Subject: Indian Point 3 Nuclear Power Plant
Docket No. 50-286
Electrical Override/Bypass Aspects of ESFs

ATTACHMENT I

ELECTRICAL OVERRIDE/BYPASS ASPECTS OF THE
ENGINEERED SAFETY FEATURES

POWER AUTHORITY OF THE STATE OF NEW YORK
INDIAN POINT 3 NUCLEAR POWER PLANT
DOCKET NO. 50-286
OCTOBER 15 , 1980

Figure 1.1

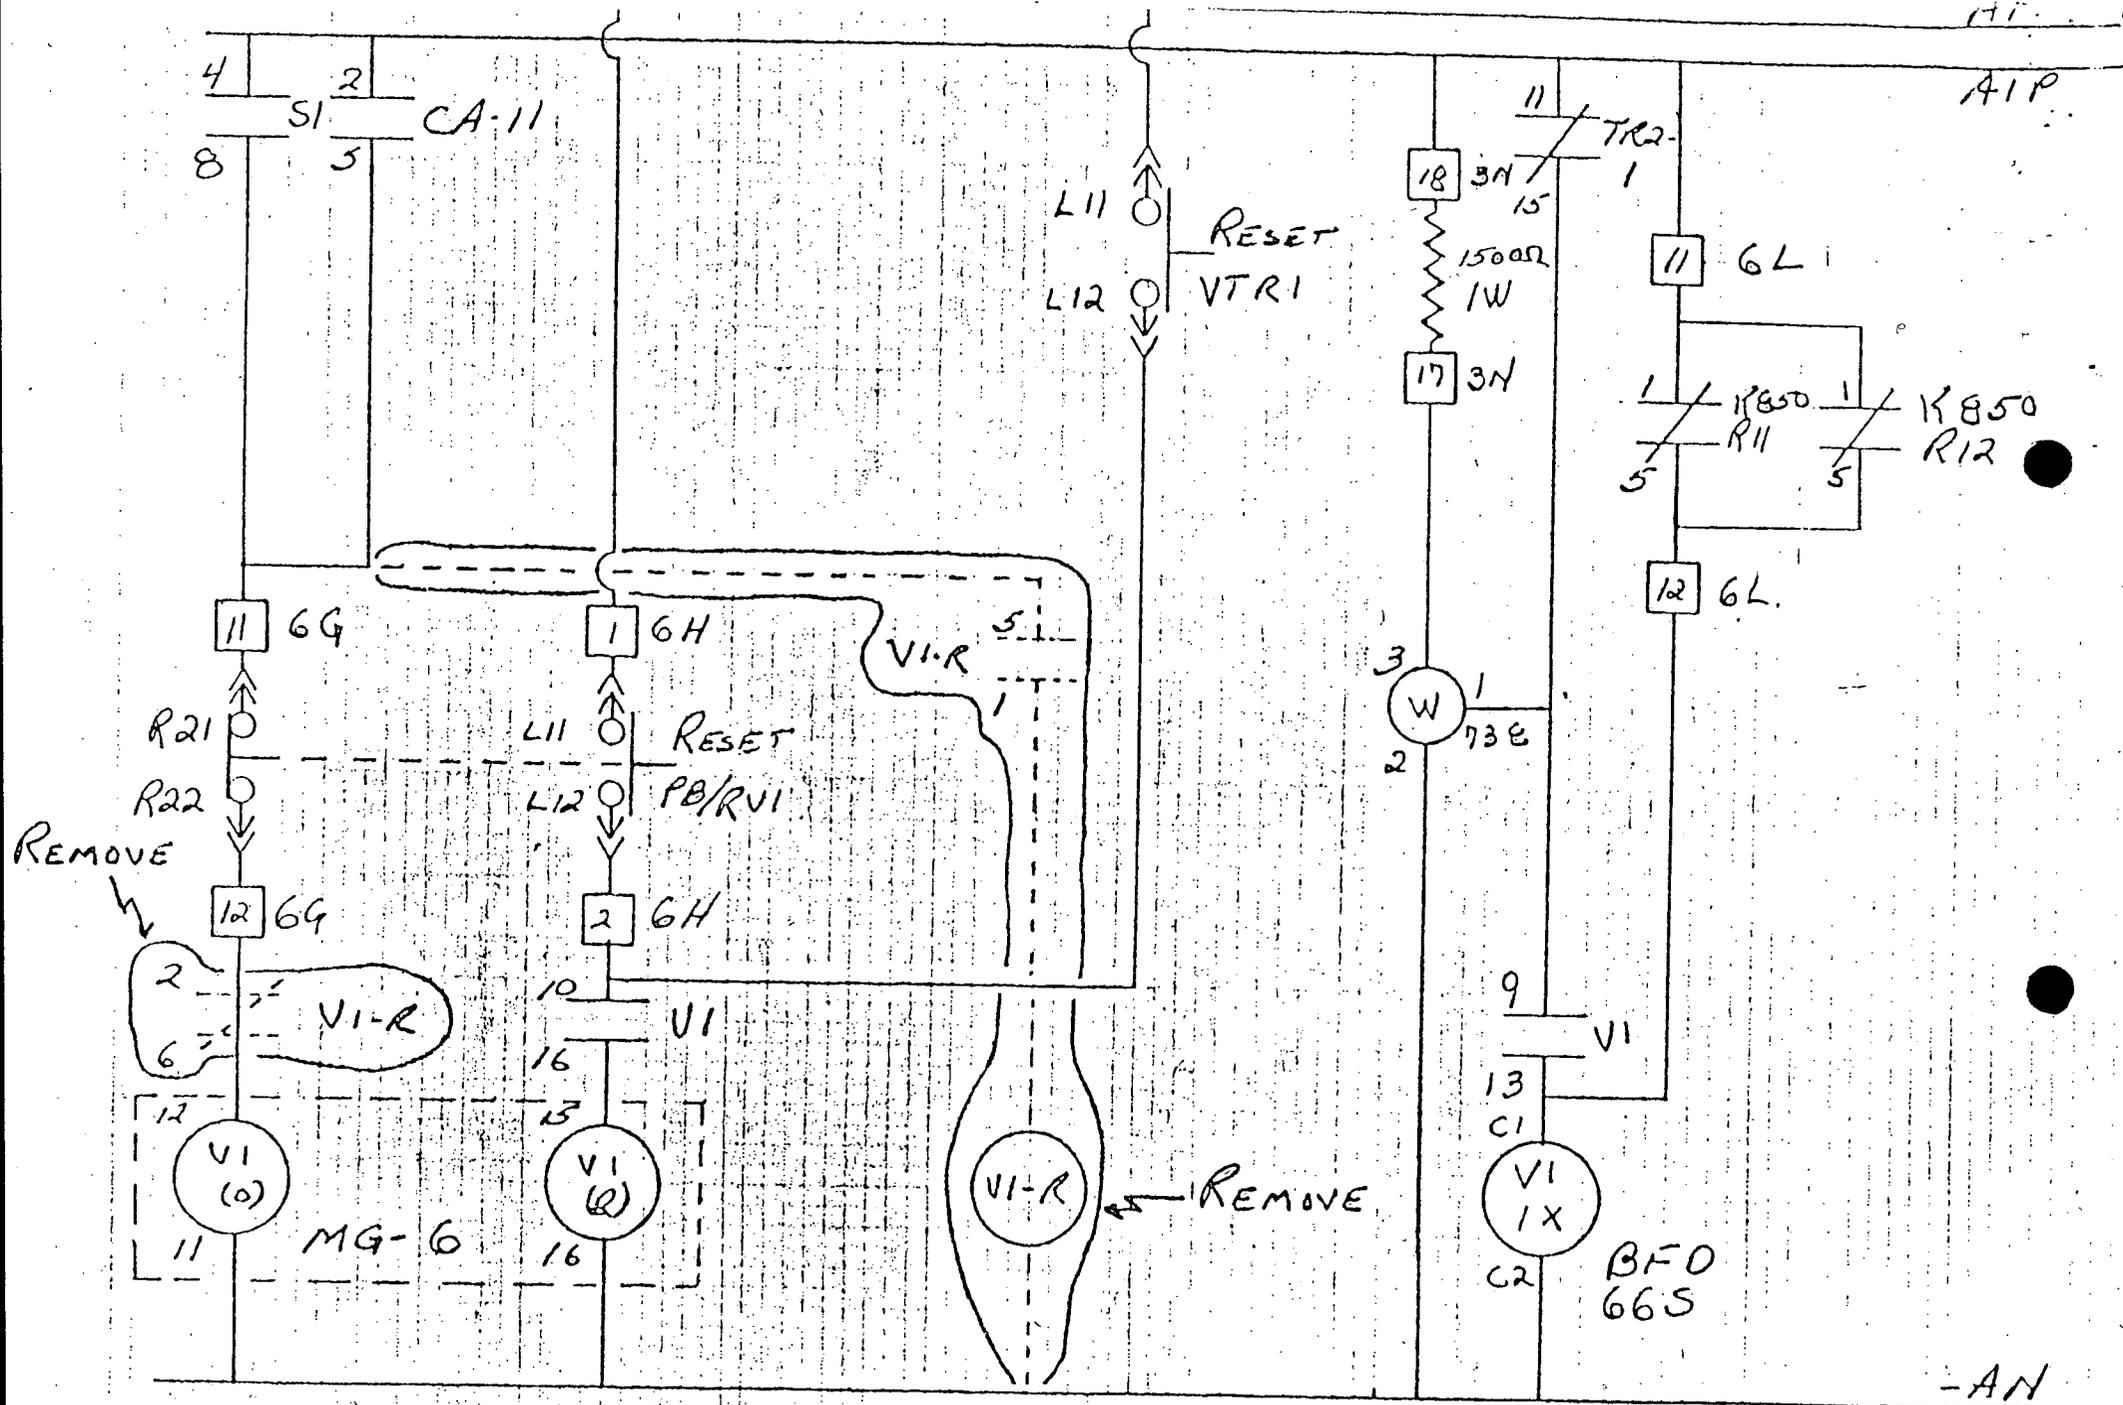
2. It appears that if the CVI reset pushbutton is depressed while an automatic safety signal is present, the system is placed in a bypass condition. In this condition all other safety signal inputs except high radiation/particulate, are blocked.

The actuation of the reset pushbutton in the Containment Ventilation Isolation System while an automatic safety signal, either Containment Spray or Containment Isolation Phase A, is present, will place the system in a block condition such that upon actuation of the other safety signal input the system will not perform its intended safety function. This block condition will be prevented from occurring by the removal of the reset relay, V1-R and V2-R, and the associated contacts in the actuation scheme. See Figure 1.1.

The removal of the reset relays and their associated contacts in the actuation scheme will be completed during a scheduled outage of sufficient duration.

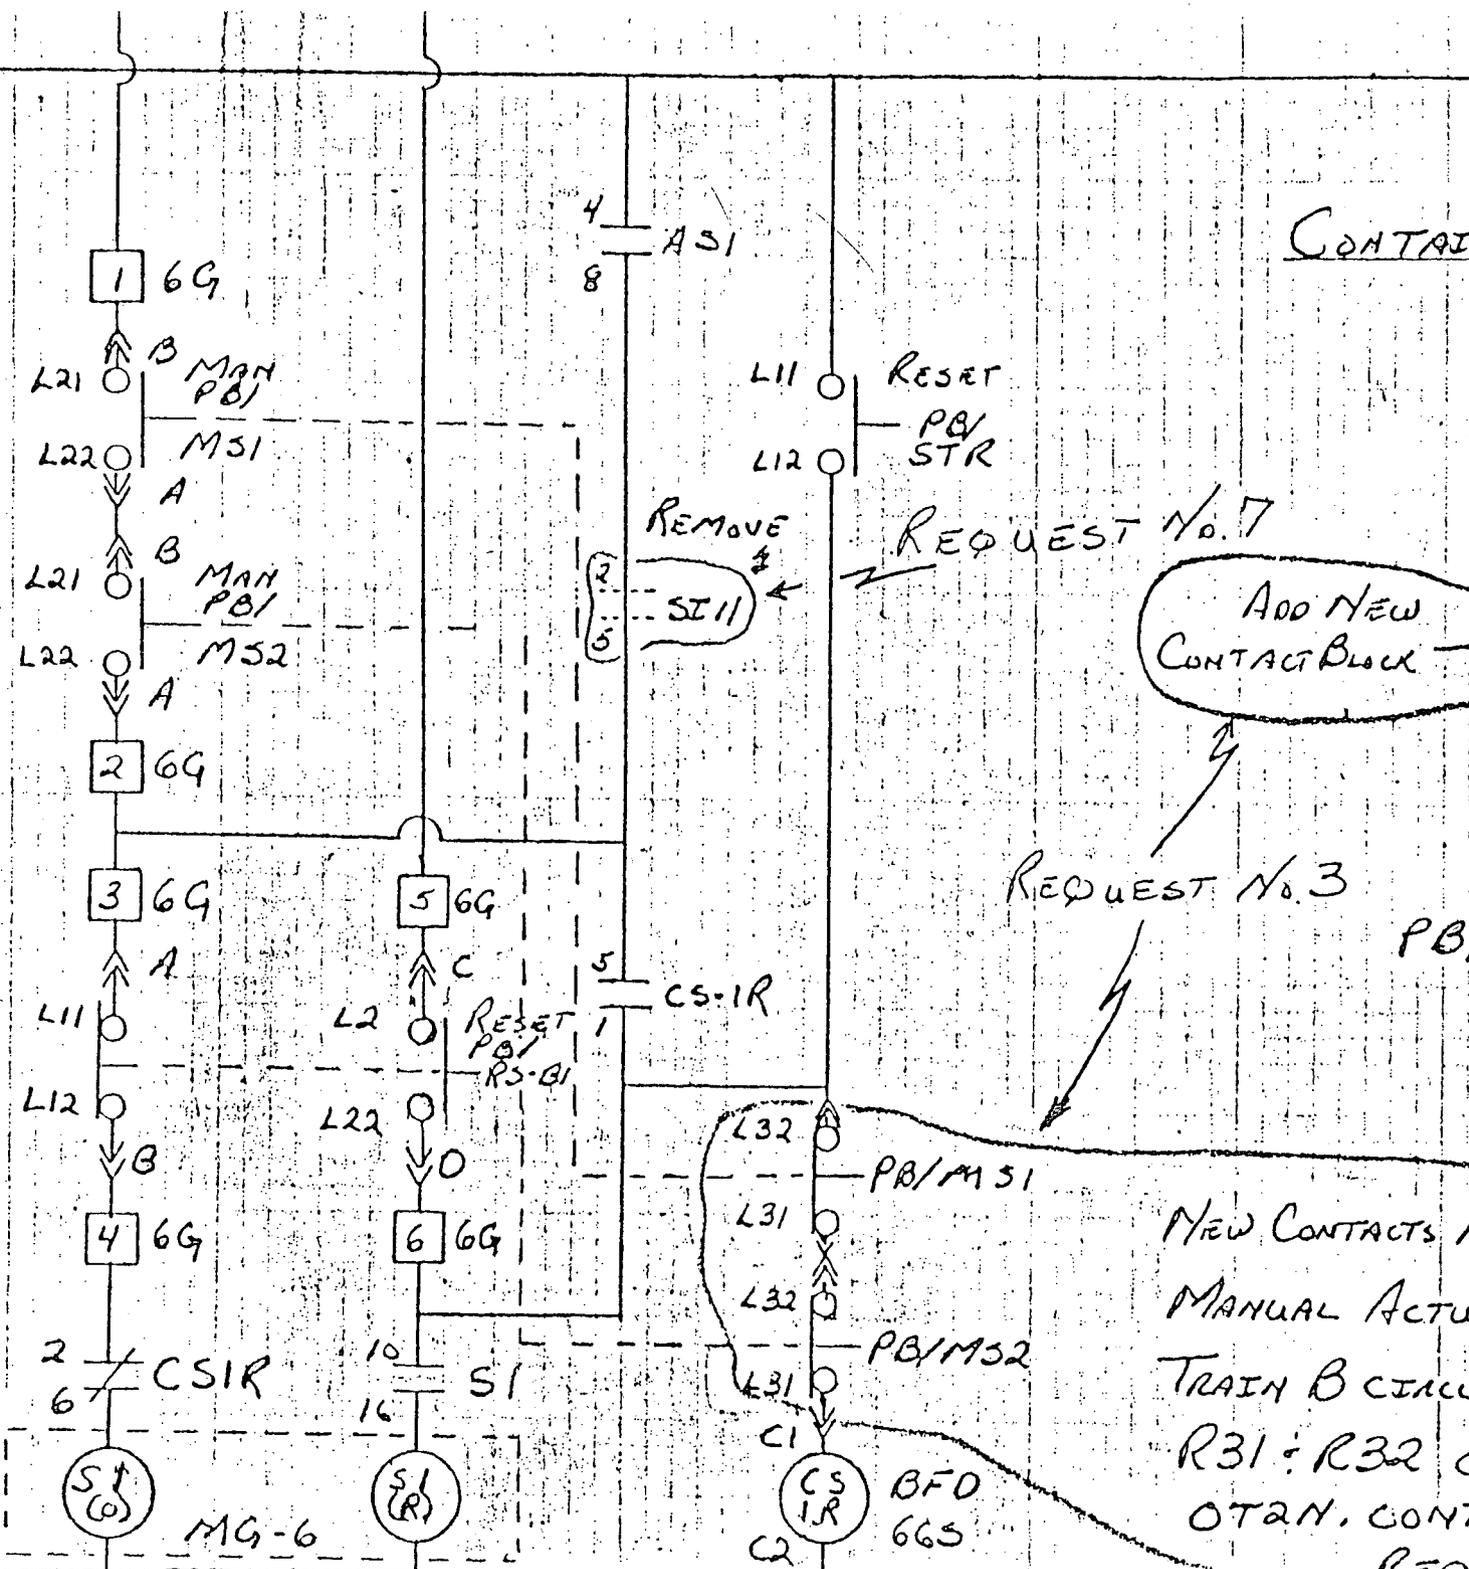
3. It appears that overriding the automatic safety signal for the CS and CI Phase A systems also blocks manual actuation and other automatic safety signals. You have already been asked by letter of August 20, 1980 to propose a modification to correct the blocking of the manual actuation. In addition, describe your proposed modification to correct the blocking of other automatic safety signals. If other Engineered Safety Features (ESF) have similar problems, propose modifications to correct them.

The installation of an additional set of normally closed contacts on the manual pushbuttons in the Containment Spray and Containment Isolation Phase A systems that are wired in series into the coil energization circuitry of the reset relays will eliminate the block on manual actuation. See Figures 3.1 and 3.2.

FIGURE 6.1

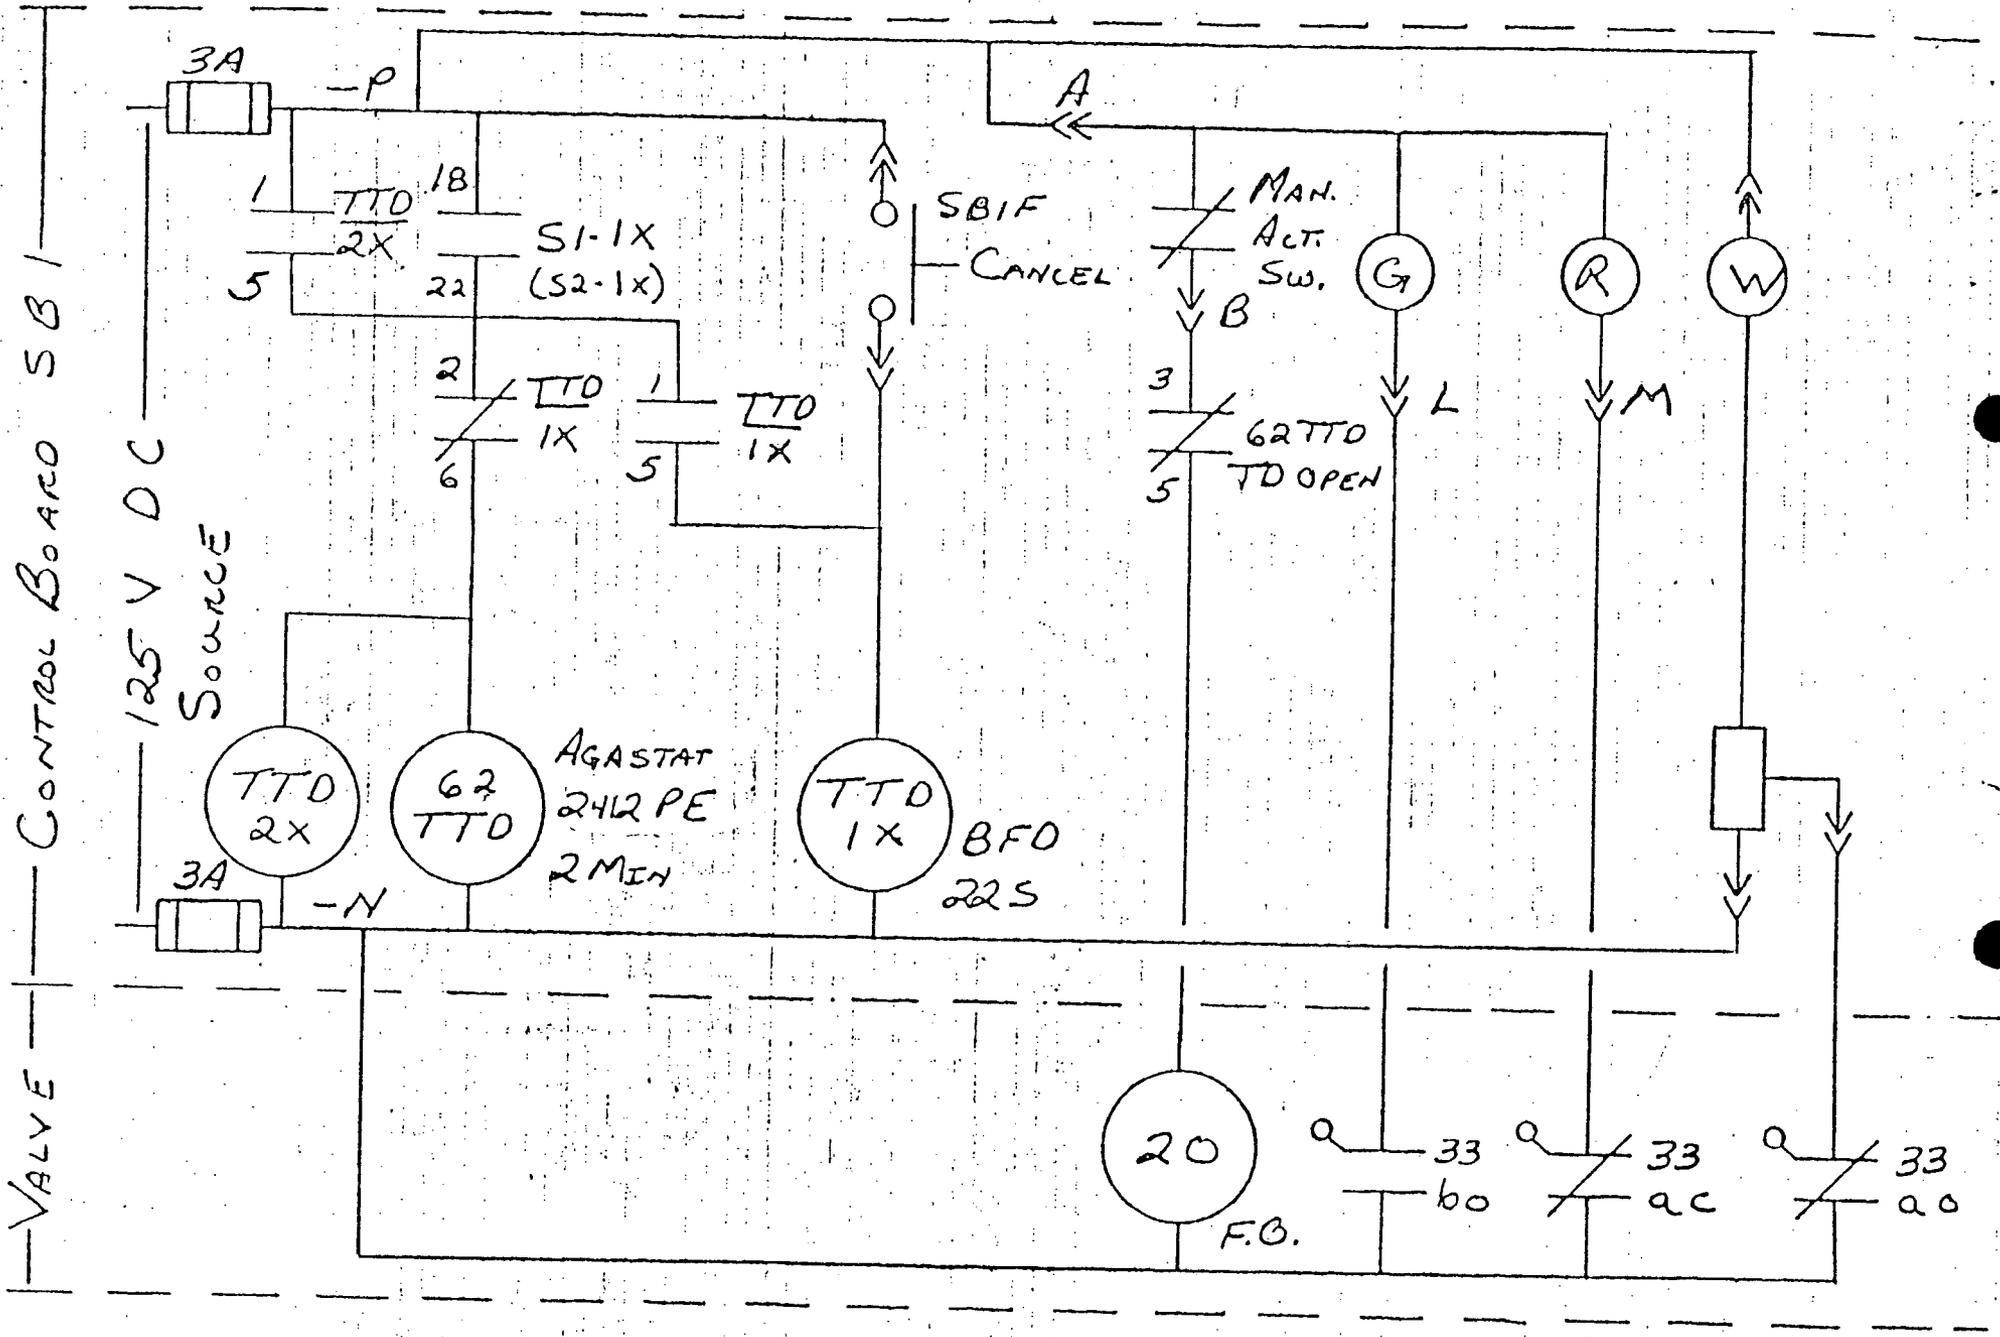
6. It appears that the CS valves change position upon overriding or resetting the system. Provide drawings of the CS valve circuitry, and changing position upon override or reset of the system.

Valves 876A (Train 1) and 876B (Train 2) open two minutes after actuation of the Containment Spray System and will close upon system reset of the containment spray system. The drawing of the containment spray additive valves 876A and 876B is provided in Figure 6.1.

The proposed modification to the circuitry of Valves 876A and 876B to prevent the valves from changing position upon reset of the containment Spray system is shown in Figure 6.2. This modification will be installed during the next scheduled outage of sufficient duration.
